MEMORANDUM February 5th, 2014

TO: Landmarks Board

SUBJECT: Public hearing and consideration of a Landmark Alteration Certificate to

demolish an existing accessory building and in its place construct a one-story, 487 sq. ft. garage and attached one-car carport, at 611 Concord Ave. in the Mapleton Hill Historic District, per section 9-11-18 of the Boulder

Proposed Site Plan

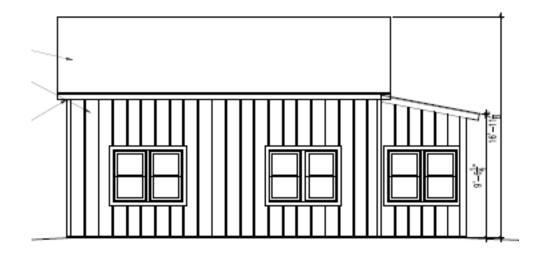
- 2. Prior building permit application and final issuance of the Landmark Alteration Certificate, the applicant shall submit revised plans for proposed carport addition to the Landmarks design review committee showing a reduction it its size and adding a pitched shed roof to make that feature more subordinate to the garage and consistent with design guideline P2 of the *Mapleton Hill Design Guidelines*.

In plan, the proposed garage is shown to be located at approximately the same location as the existing accessory building. The front-gable portion of the new garage is shown to measure 16 ft. by 24 ft., with a 6'6 shed roof portion located at the north side of the building, and a $13' \times 24'$ carport at the east side.
